**Question(s):** 9/15**LIAISON STATEMENT****Source:** ITU-T Study Group 15**Title:** Ethernet equipment functional blocks (G.8021/Y.1341)

ITU-T SG15 Q9 is pleased to inform you that the Amendment 2 to Recommendation G.8021/Y.1341 “Characteristics of Ethernet transport network equipment functional blocks” has been approved in February 2010.

#### Draft Amendment 2

This second amendment contains additional material to be incorporated into ITU-T Recommendation G.8021/Y.1341. It presents enhancements about ETH Connection function. It also presents enhancements about ODU2P to Ethernet PP-OS adaptation function and a reference to the ODU0P to 1 GbE client adaptation function.

Figure 9-3/G.8021/Y.1341 – ETH Adapted Information

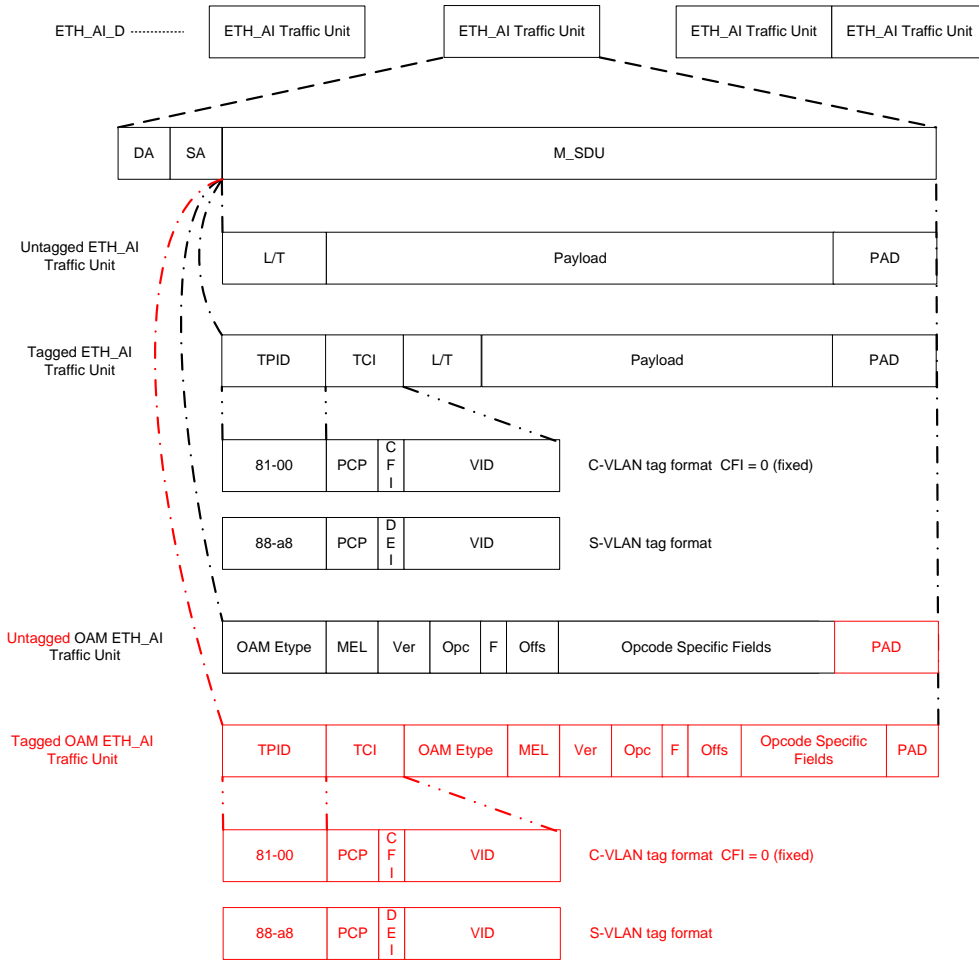
4. Update figure 9-3

Added flags and Offset fields in RED:

**Figure 9-10/G.8021/Y.1341 – ETH Connection function with ETH\_FF processes**

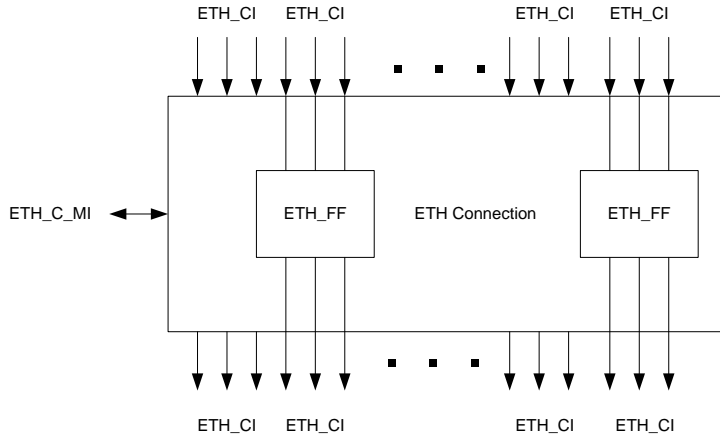
## 7. Replace sub-clause 9.1

The processes associated with the ETH\_C function are as depicted in Figure 9-10.

ETH\_CI traffic units are forwarded between input and output ETH flow points by means of an ETH flow forwarding process. ETH flow points may be allocated within a protection group. ETH flow points may be allocated within a flow port group (to support split-horizon).

**Figure 9-6/G.8021/Y.1341 – ETH Flow Forwarding Process**

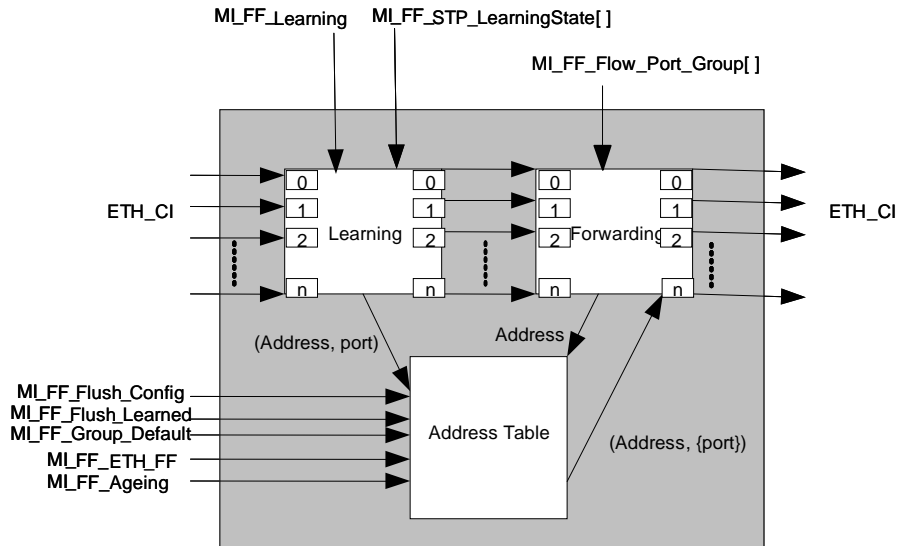
**8. Replace sub-clause 9.1.1**

The ETH Flow Forwarding process, as shown in Figure 9-10, forwards ETH\_CI signals at its input ports to its output ports. The forwarding may take into account the value of the DA field of the ETH\_CI Traffic Unit and the flow port group of which the input flow point is a member.

**Figure 9-7/G.8021/Y.1341 – ETH Flow Forwarding Process in SVL mode**

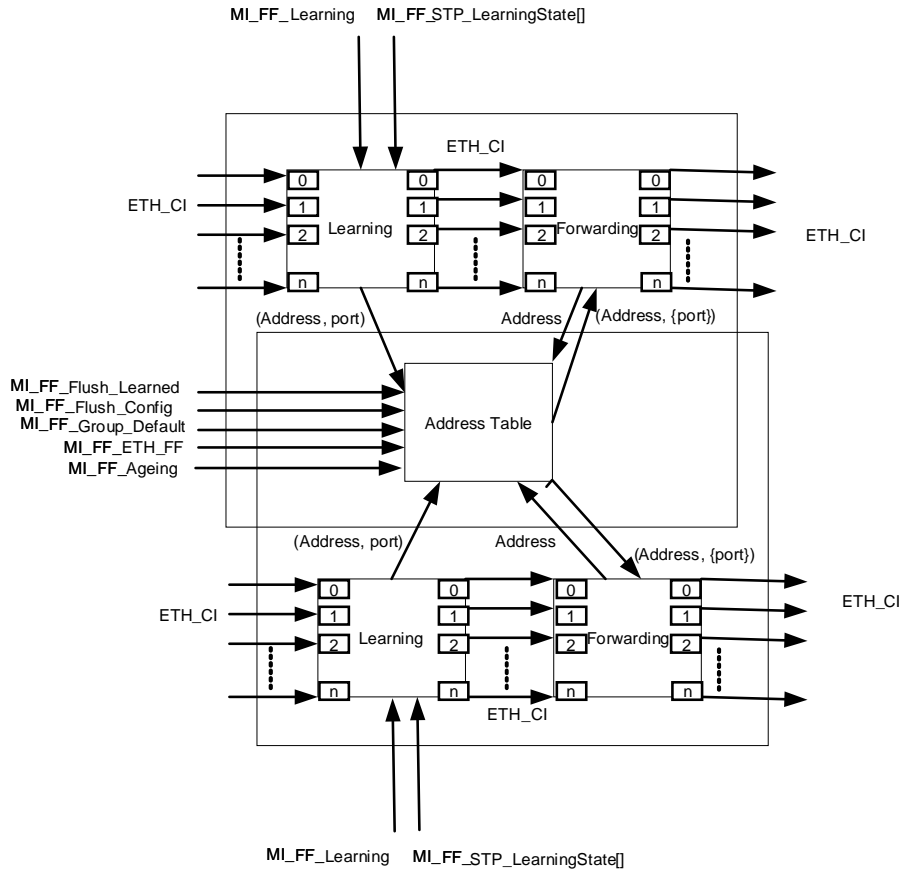
Figure 9-6 shows the ETH\_FF in case of Individual VLAN Learning (IVL) mode. In this mode each ETH\_FF has its own Address Table. Figure 9-7 shows the process for the case of Shared VLAN Learning (SVL) mode. In this mode two or more ETH\_FF share the Address Table process.

Figure 9-11/G.8021/Y.1341 – SNC/S Atomic Functions

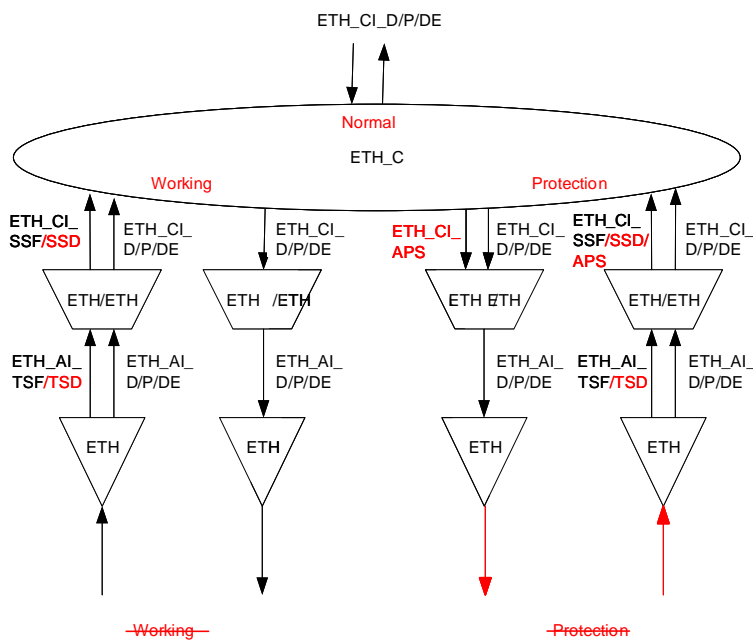
Replace figure 9-11:

Figure 9-12/G.8021/Y.1341 – SNC/S Protection Process

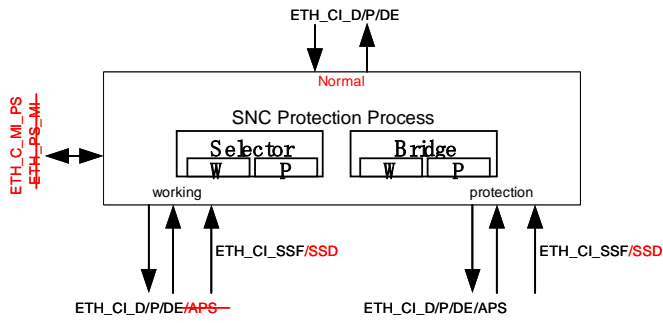
11. Update figure 9-12

Add and change the text in RED:

Figure 9-21/G.8021/Y.1341 – Sink direction ETHx/ETH\_A\_Sk process

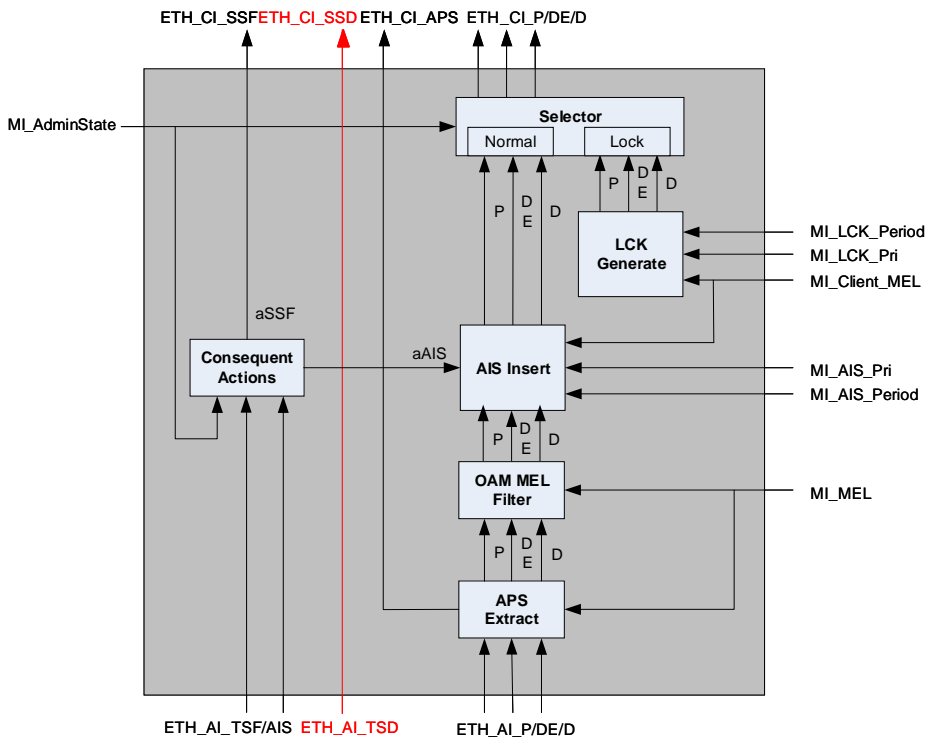
**14. Update table 9-6 and Figure 9-21**

Add the text in RED:

Figure 1/G.8021/Y.1341 – Overview of G.8021/Y.1341 atomic model functions

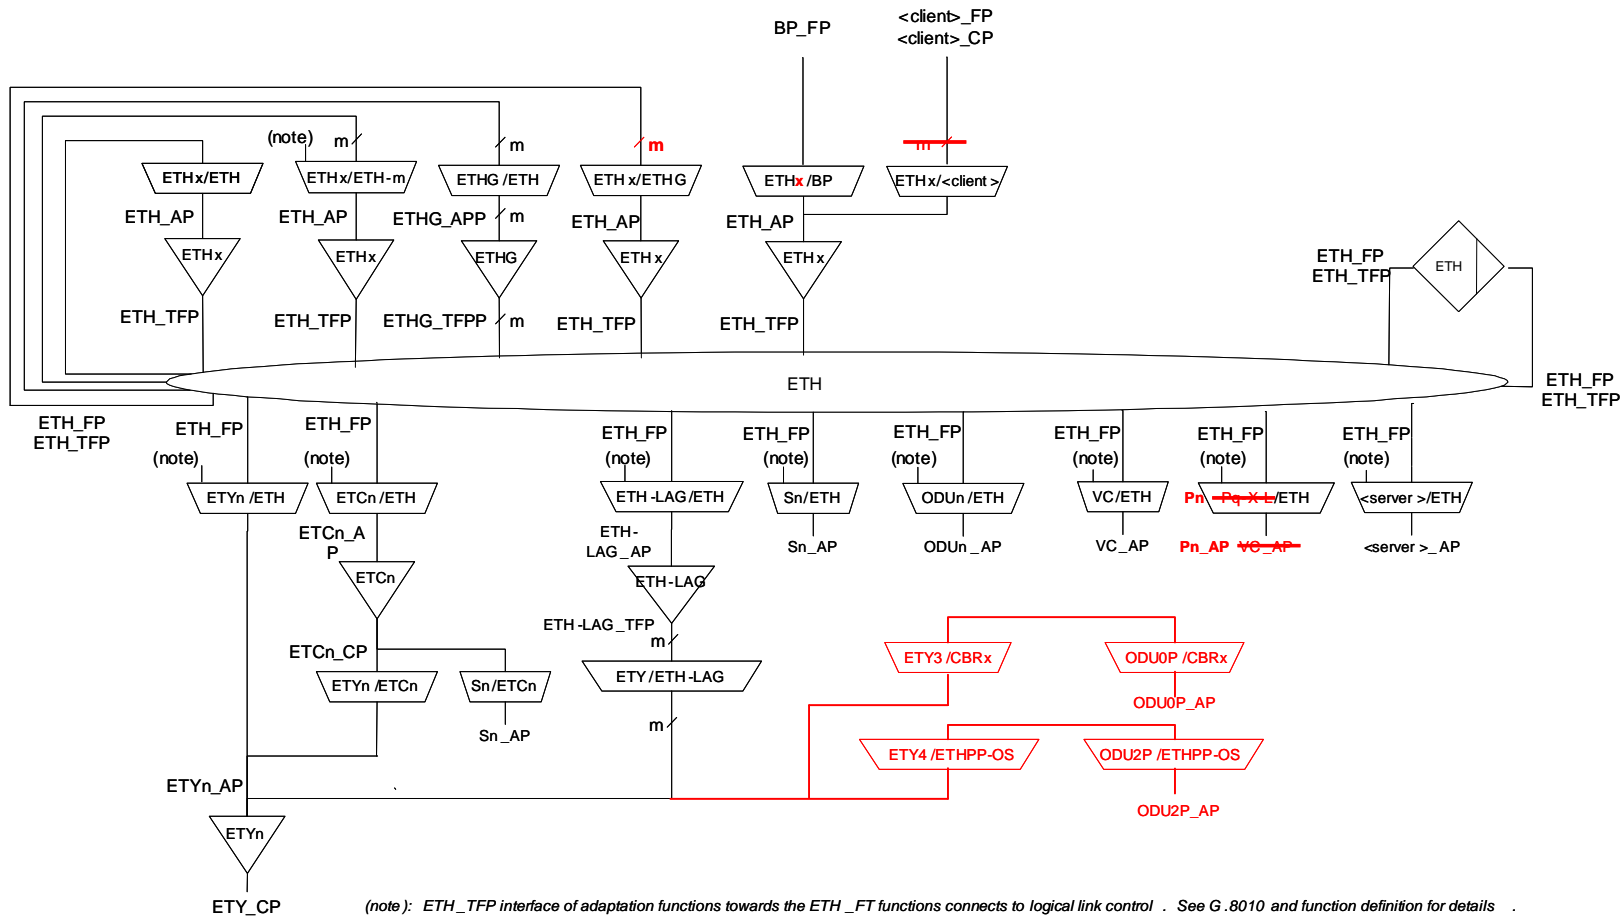
### 16. Update figure 1

Add or change the text/figure in RED:

Figure 9-x+2 – ETHDi/ETH\_A\_Sk function

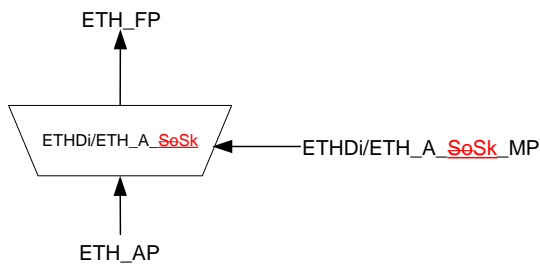
18. Update figure 9-x+2 (in Amd1)

Replace So by Sk.

Figure 6-3/G.8021/Y.1341 – dDEG detection and clearance process

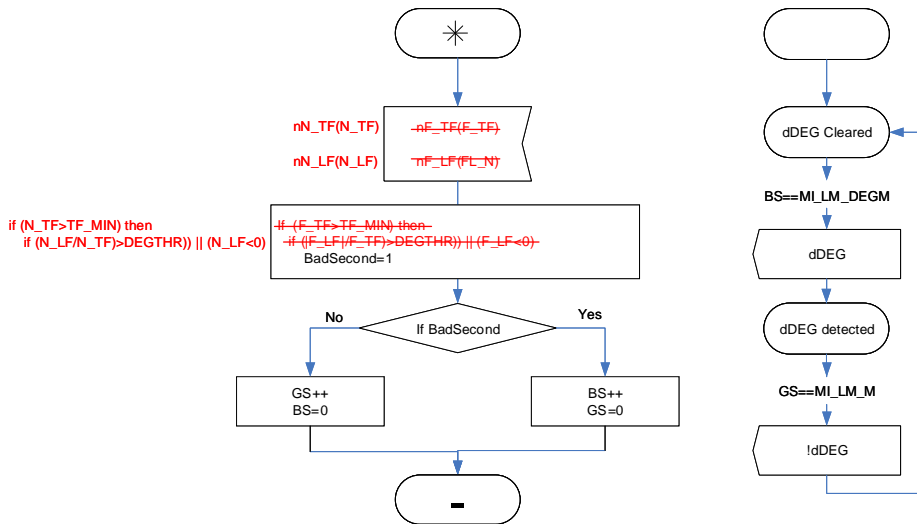
Its detection and clearance are defined in Figure 6-3.

Every second the statemachine receives the 1 second counters for ~~far~~-near end received and transmitted frames and determines whether the second was a Bad Second. The defect is detected if there are MI\_LM\_DEGM consecutive Bad Seconds and cleared if there are MI\_LM\_M consecutive Good Seconds.

In order to declare a Bad Second the number of transmitted frames must exceed a threshold (TF\_MIN). If this is true then a Bad Second is declared if either the Frame Loss is negative (i.e. there are more frames received than transmitted) or the Frame Loss Ratio (lost frames/transmitted frames) is greater than MI\_LM\_DEGTHR.

**Figure 9-x/G.8021/Y.1341 – Ring Protection Atomic Functions and Control Process**

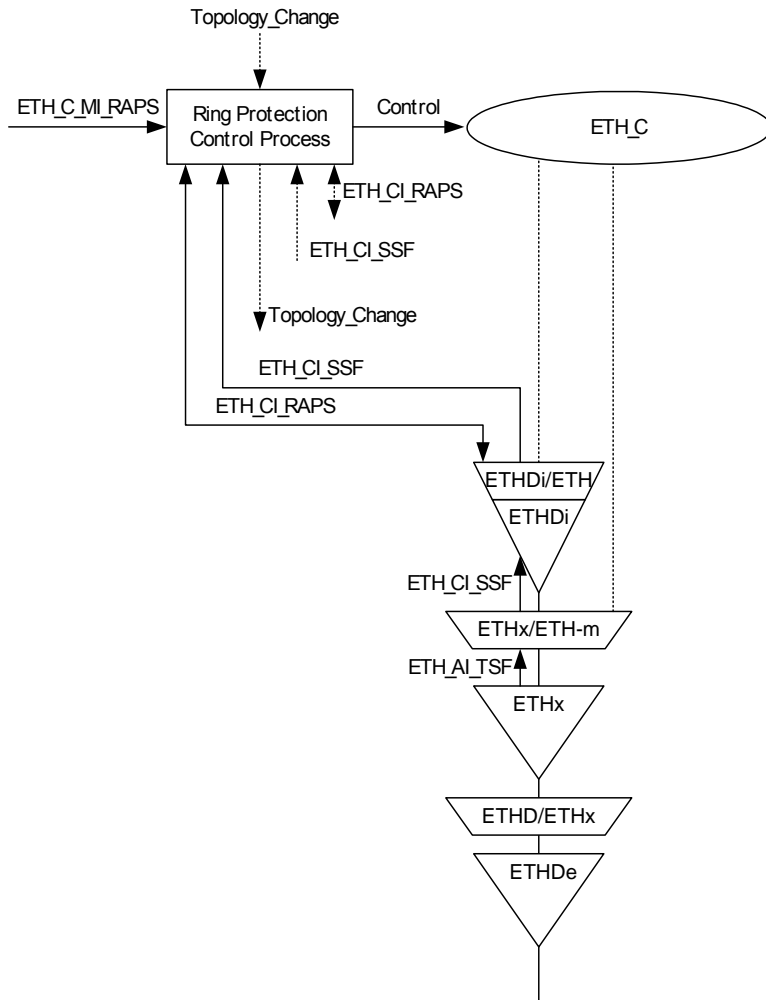
33. Insert the following sub-clause after sub-clause 9.1.3

Figure 9-x shows a subset of the atomic functions involved, and the signal flows associated with the ring protection control process. This is only an overview of the Ethernet Ring Protection Control Process as specified in ITU-T Rec. G.8032/Y.1344. The ETH\_FT\_Sk provides the TSF protection switching criterion via the ETH/ETH\_A\_Sk function (SSF). G.8032 specifies the requirements, options and the ring protection protocol supported by the ring protection control process.
